STATE OF NORTH CAROLINA  
**DEPARTMENT OF TRANSPORTATION**

Subject: Proposed Glen Lennox Mixed Use Re-development  
Located on NC 54 at US 15-501  
Review of Traffic Impact Study

# Directional Crossover Access

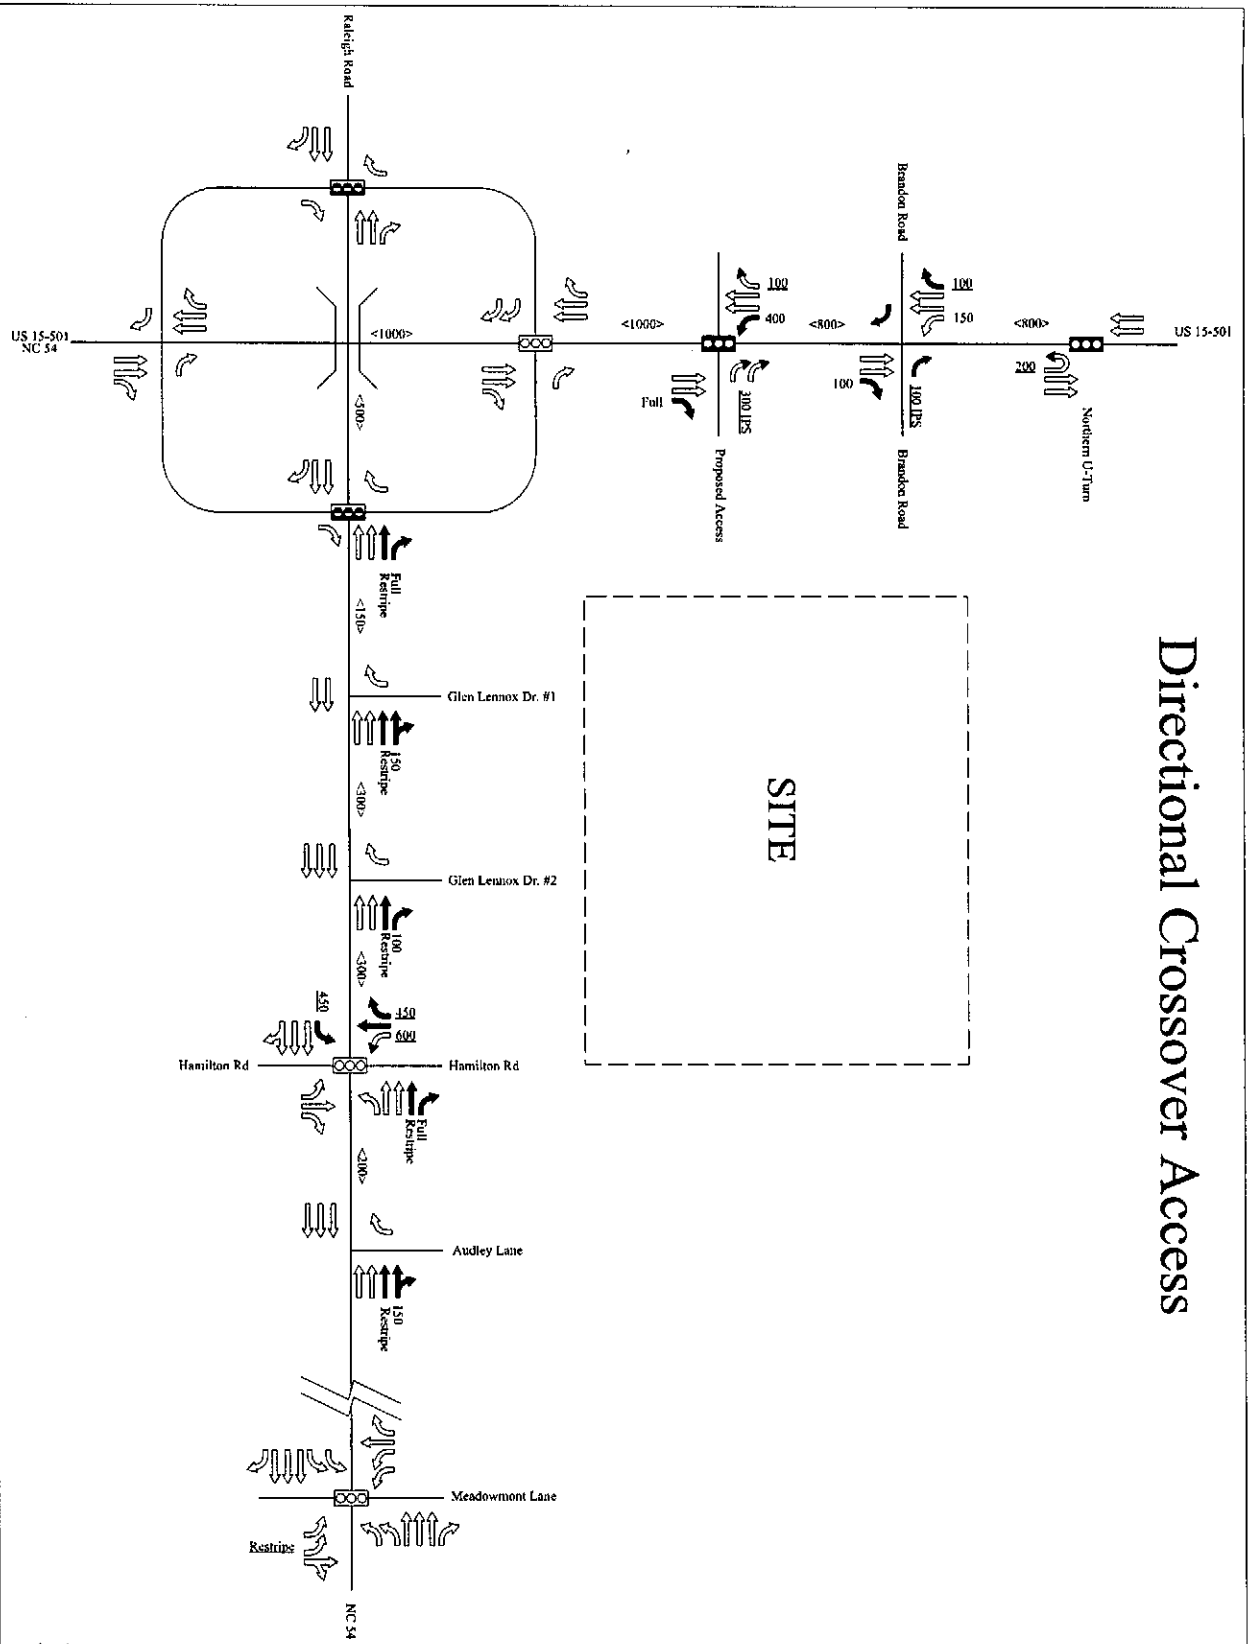
Because of the specific guidelines relative to this Strategic Highway Corridor as well as analysis provided in the TIA, NCDOT cannot support a new all-movement access on US 15-501 as proposed, due to the anticipated negative impacts on traffic operation on the corridor. NCDOT considers the following two scenarios to be acceptable alternatives that provide for site access while preserving mobility on the corridor.

This configuration provides for direct left turns from US-15-501 to both the proposed new access and Brandon Road while redirecting left turn and through movements from the proposed access, Brandon Road and Christopher Road to U-turns controlled by simple traffic signals located to the north of Brandon Road and at the proposed access location. In addition, the northbound acceleration lane from the NC 54 westbound ramp is extended to terminate as an exclusive right turn lane at the proposed access to provide for acceptable acceleration and weaving distance to accommodate traffic maneuvers between the ramp and the intersection. Required lane configurations, storage lengths, and additional geometric detail is provided on the attached graphic labelled "Directional Crossover Access"

Based on evaluation of traffic modeling, NCDOT concurs with the HNTB recommendation for provision of dual lanes serving left turn movements at Hamilton Road as the preferred option to preserve efficiency at this intersection and along the corridor. However, in the event that it is demonstrated that construction of dual left turn lanes is not feasible due to right of way constraints, a single left turn lane scenario is acceptable subject to signal timing and operation which provides preference to optimized progression on NC 54.

NCDOT is agreeable to retention of the existing Audley Lane right-in right-out access subject to provision of a right turn deceleration lane.

# Brandon Road Conventional Access

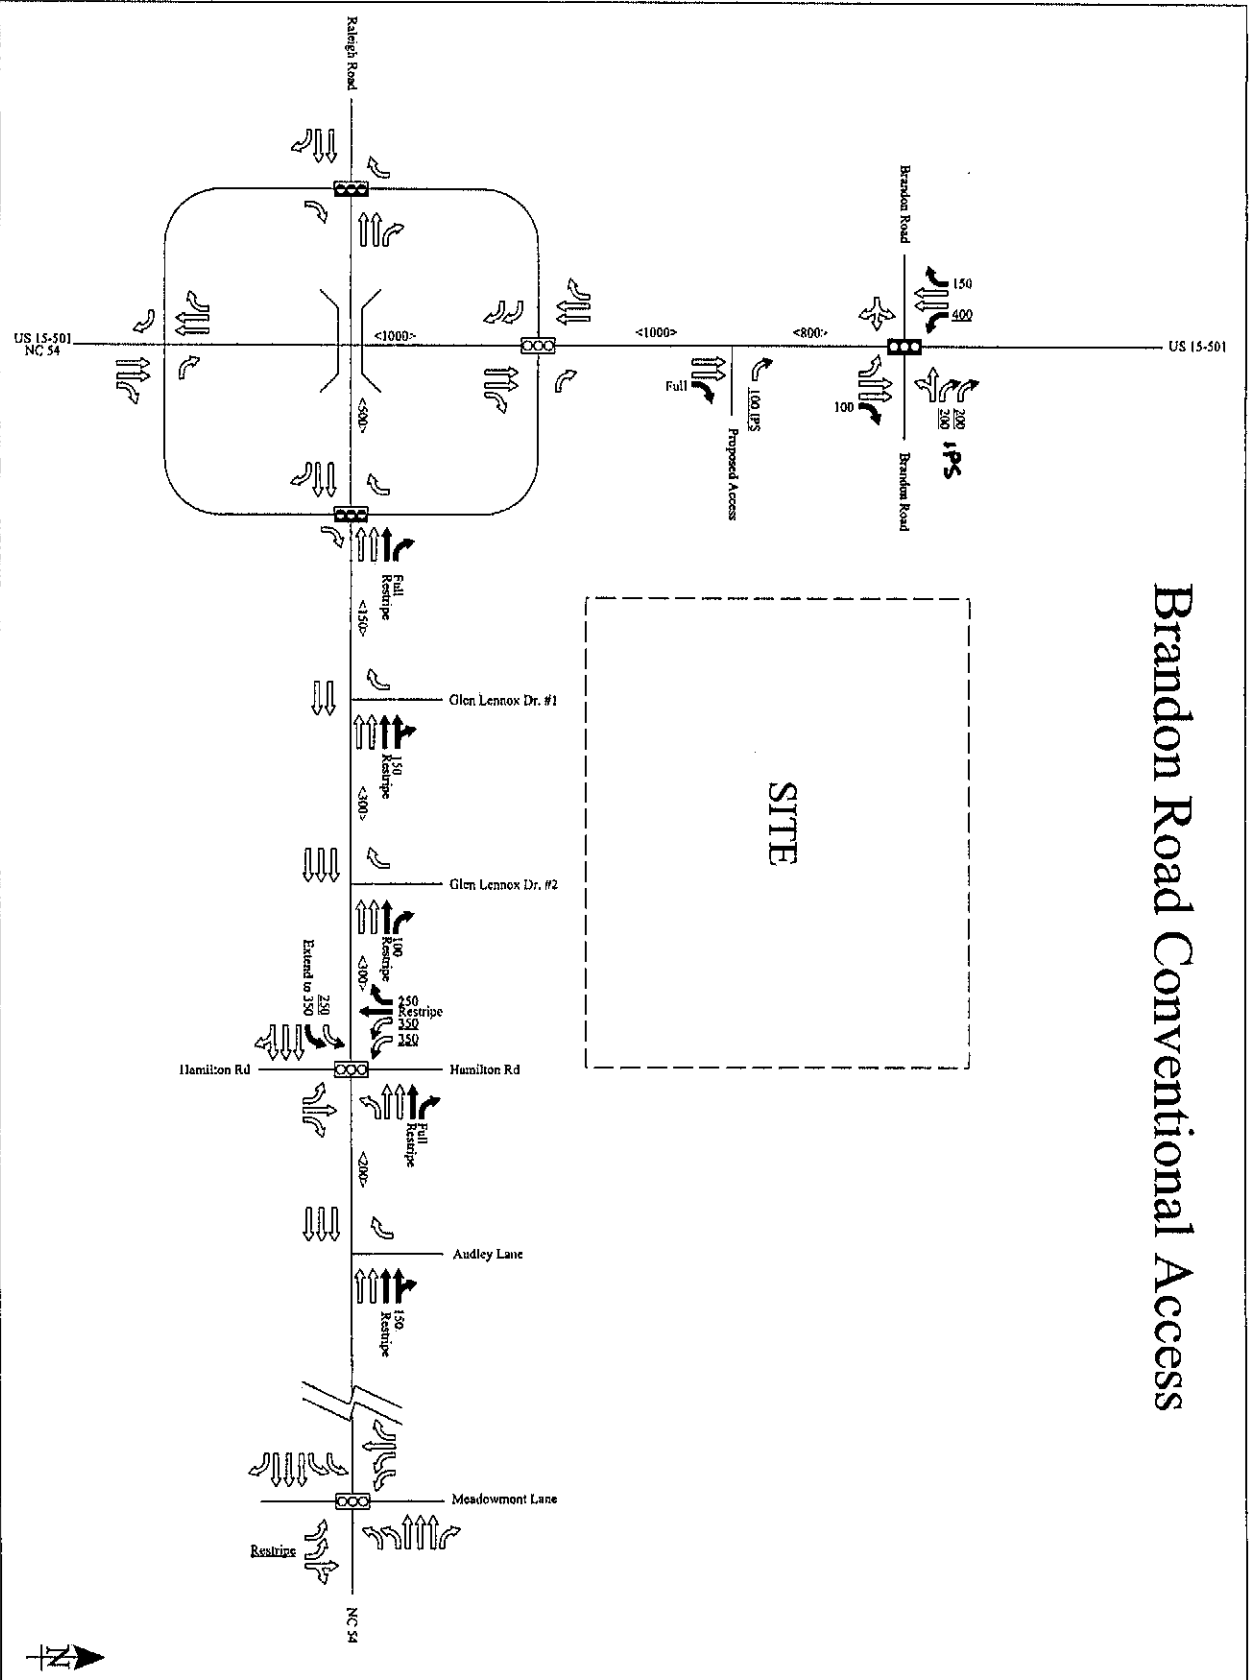
#### **Scenario 2- Brandon Road Conventional Access**

This configuration provides for an all-movement access at the existing Brandon Road/Christopher Road intersection controlled by a single multi-phase traffic signal. The proposed site access is restricted to right-in right-out only. In addition, as in scenario 1, the northbound acceleration lane from the NC 54 westbound ramp is extended to terminate as an exclusive right turn lane at the proposed access to provide for acceptable

acceleration and weaving distance to accommodate traffic maneuvers between the ramp and the intersection. Required lane configurations, storage lengths and additional geometric detail is provided on the attached graphic labelled “Brandon Road Conventional Access”
